**SOLICITATION AMENDMENT
MODIFICATION DE L'INVITATION**

Title - Sujet Roof Replacement	
Solicitation No. - N° de l'invitation EP922-171041/A	Amendment No. - N° modif. 002
Client Reference No. - N° de référence du client AAFC EP922-171041	Date 2016-08-25
GETS Reference No. - N° de référence de SEAG PW-\$PWU-201-10829	
File No. - N° de dossier PWU-6-39113 (201)	CCC No./N° CCC - FMS No./N° VME
Solicitation Closes - L'invitation prend fin at - à 02:00 PM on - le 2016-09-02	
Time Zone Fuseau horaire Mountain Daylight Saving Time MDT	
F.O.B. - F.A.B. Plant-Usine: <input type="checkbox"/> Destination: <input type="checkbox"/> Other-Autre: <input type="checkbox"/>	
Address Enquiries to: - Adresser toutes questions à: Ho (RPC), Hector	Buyer Id - Id de l'acheteur pwu201
Telephone No. - N° de téléphone (780) 901-0989 ()	FAX No. - N° de FAX (780) 497-3510
Destination - of Goods, Services, and Construction: Destination - des biens, services et construction: See Herein

This amendment has been raised to attach Addendum #001 and to extend the closing date

Project Name/Title du projet
Lethbridge Dairy Barn Roof Replacement
Lethbridge Research Centre

7 PHASING A0.1 NTS

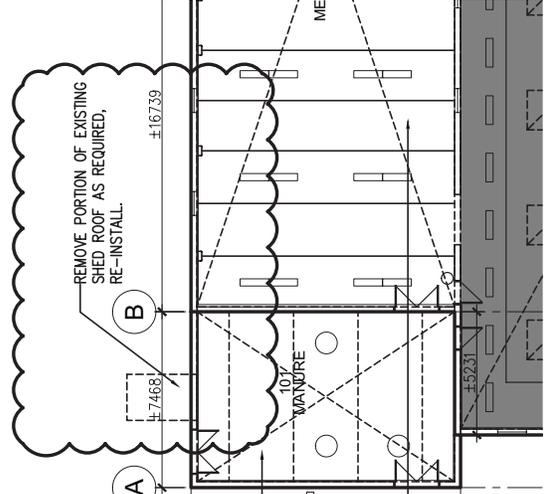
3.1	<p><u>Drawing 7/A0.1 – Phasing</u></p> <p>Add: GENERAL NOTE FOR ALL PHASES: OPERATIONS AND EQUIPMENT IN 101 MANURE AREA IS TO REMAIN IN SERVICE 24 HOURS A DAY, 7 DAYS A WEEK FOR THE DURATION OF THE PROJECT.</p> <p>Refer to attached sketch ASK1.1.</p>
-----	----------------------------------------------------------------------------------------------------------------------------------------------------------------------------------------------------------------------------------------------------------------------------------------------

GENERAL NOTE FOR ALL PHASES:
OPERATIONS AND EQUIPMENT IN 101 MANURE
AREA IS TO REMAIN IN SERVICE 24 HOURS A
DAY DURING THE DURATION OF
THE PROJECT.

1 RCP DEMOLITION PLAN A2.1 1:200

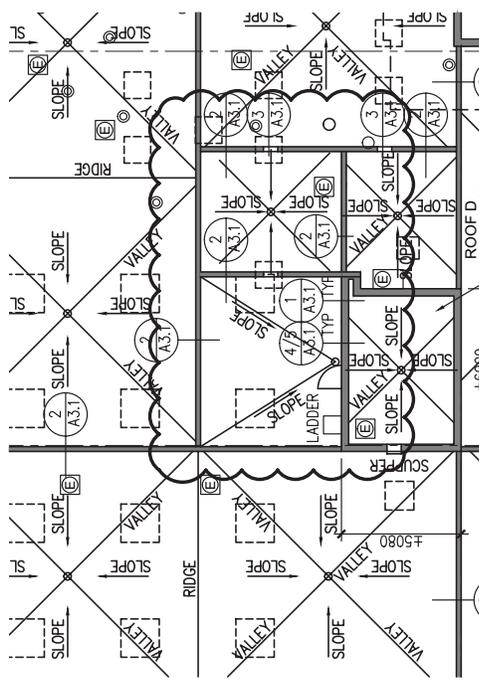
3.2	<p><u>Drawing 1/A2.1 – RCP Demolition Plan</u></p> <p>Revise to read: 101 MANURE: REMOVE PRECAST CONCRETE CHANNEL PLANKING AND STEEL ROOF JOISTS. -REMOVE EXISTING CONCRETE BLOCK ON GRIDLINE B AND PREPARE FOR NEW WORK - REFER TO STRUCTURAL. HAZMAT ABATEMENT IS REQUIRED AT THIS LOCATION DUE TO VERMICULITE IN CORES. -CUT OFF ALL EXISTING STRUCTURE FLUSH WITH WALLS, DO NOT REMOVE EMBEDS ON GRIDLINES B AND 2 - WALLS CONTAIN HAZMAT VERMICULITE.</p> <p>Add: REMOVE PORTION OF EXISTING SHED ROOF AS REQUIRED, RE-INSTALL.</p> <p>Refer to attached sketch ASK1.1.</p>

101. MANURE:
REMOVE PRECAST CONCRETE CHANNEL
PLANKING AND STEEL ROOF JOISTS.
--REMOVE EXISTING CONCRETE BLOCK ON
GRIDLINE B AND PREPARE FOR NEW WORK
REFER TO STRUCTURAL HAZMAT
ABATEMENT IS REQUIRED AT THIS LOCATION
DUE TO VERMICULITE IN CORES.
--CUT OFF ALL EXISTING STRUCTURE FLUSH
WITH WALLS. DO NOT REMOVE EMBEDS ON
GRIDLINES B AND 2 - WALLS CONTAIN
HAZMAT VERMICULITE.

2 ROOF CONSTRUCTION PLAN A2.2 1:200

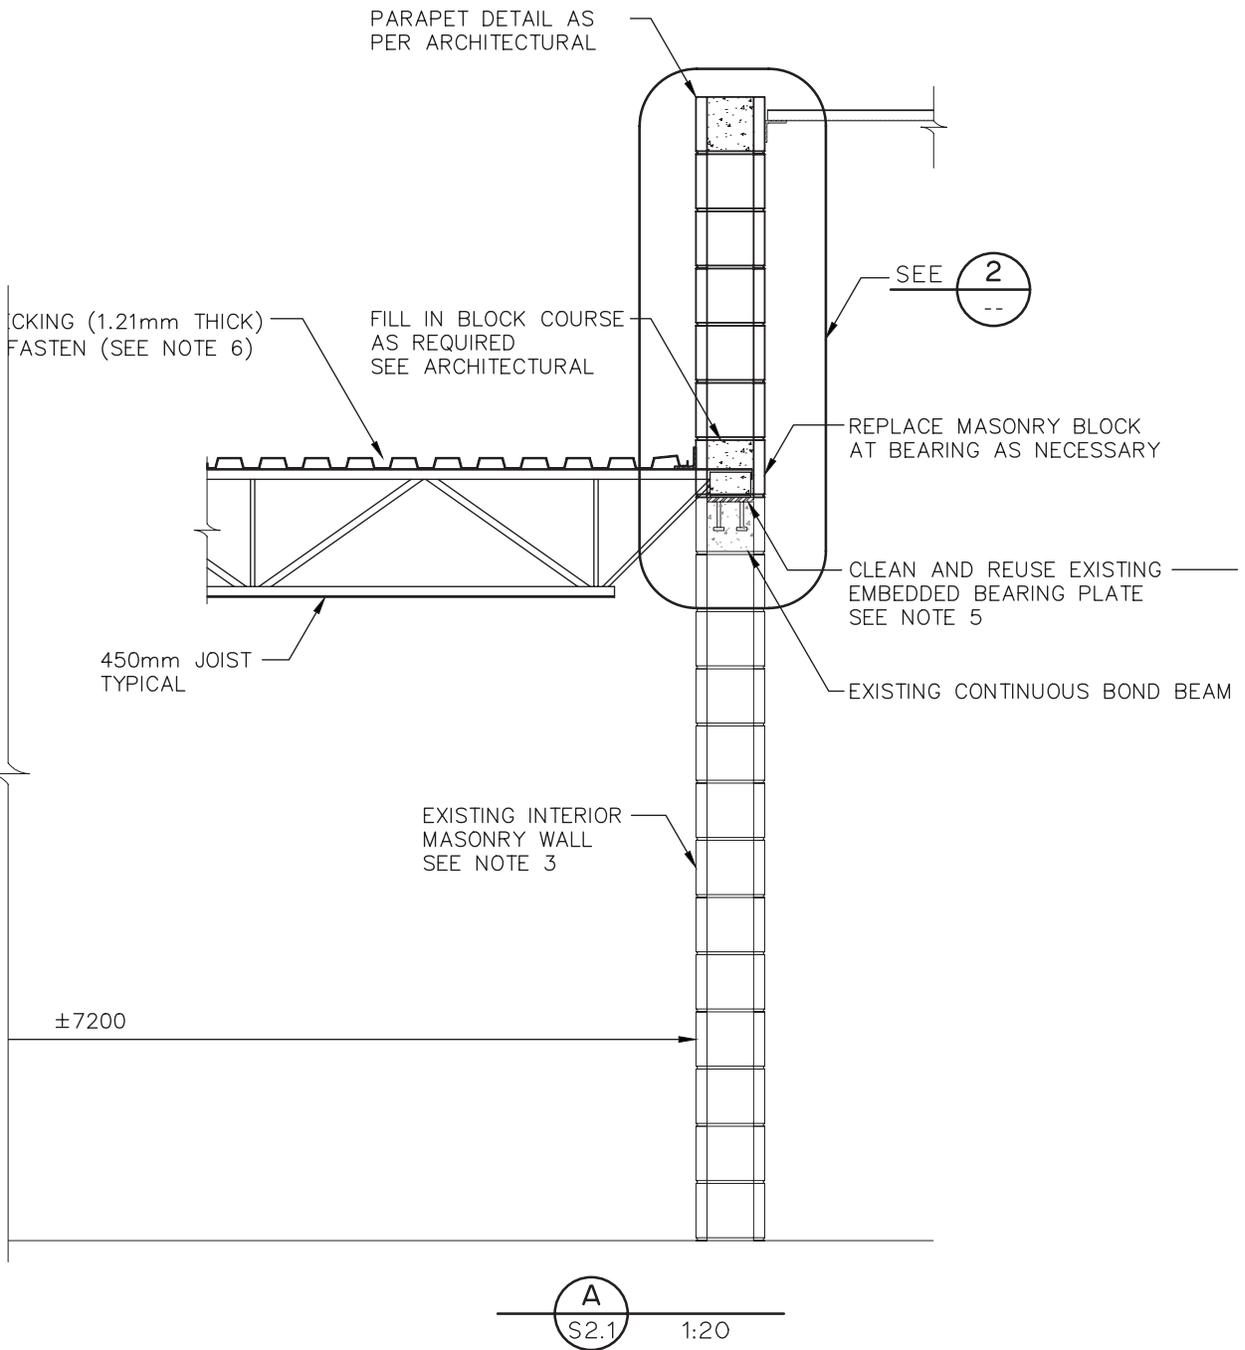
3.3	<p><u>Drawing 2/A2.2 – Roof Construction Plan</u></p> <p>In order to accommodate the door sill and mechanical vent on the north side of the roof penthouse, an additional roof curb, gutter and scupper are required. Slope this area of the roof to the drain; locate drain adjacent to wall.</p> <p>Refer to attached sketch ASK1.1.</p>

DRAWING: SSK2

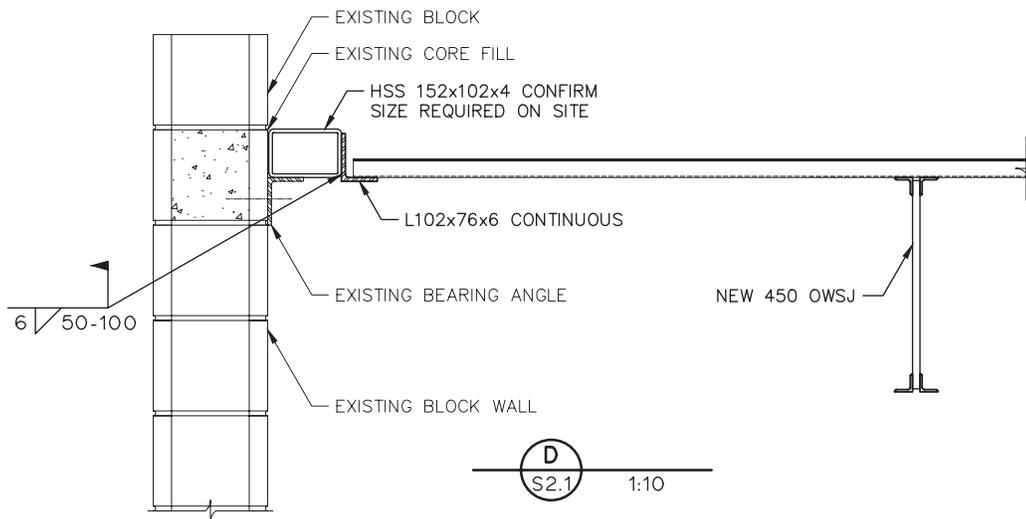
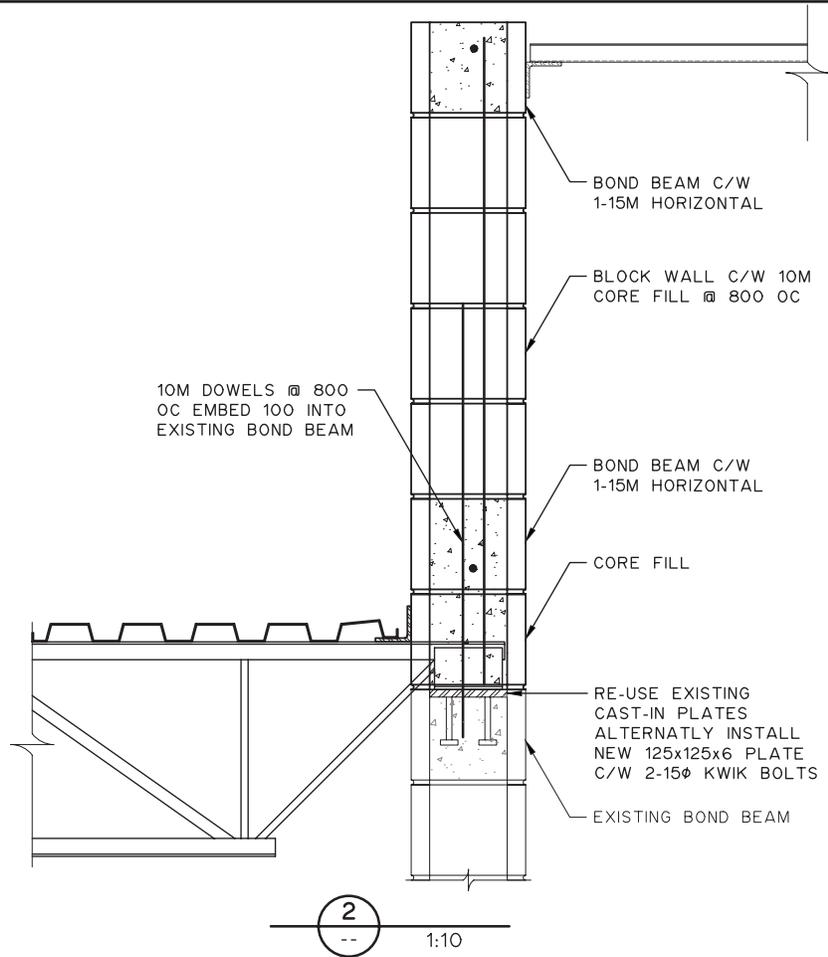
3.5	<p><u>Drawing S2.1 – Structural Details</u></p> <p>Add: See section details for proposed structural work on Structural Detail on SSK001, SSK002, and SSK003.</p>
